**COMMONWEALTH OF KENTUCKY
BEFORE THE PUBLIC SERVICE COMMISSION**

Electronic Application Of Kentucky Power)	
Company For A Certificate Of Public Convenience)	
And Necessity To Construct A 138 kV)	Case No. 2020-00062
Transmission Line And Associated Facilities)	
In Pike And Floyd Counties (Kewanee-Enterprise)	
Park 138 kV Transmission Line Project))

Notice of Modification of Kewanee 138 kV Substation Layout

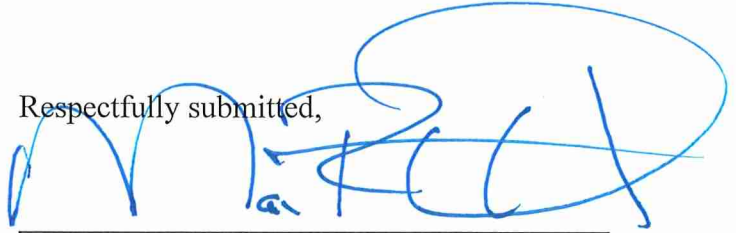
The Kewanee 138 kV Substation layout has been updated from that provided with the Company’s application. The modifications are designed to improve system operations, reliability, and safety.

Changes to the layout include the relocation of the 34.5kV transformer and distribution bay resulting in a source/load/source/load ring bus arrangement. The 138 kV capacitor bank will be relocated to the new 34.5 kV transformer position along with the addition of a 138 kV high-side circuit switcher. These changes are not expected to impact the transmission lines or ROW, or affect the station footprint.
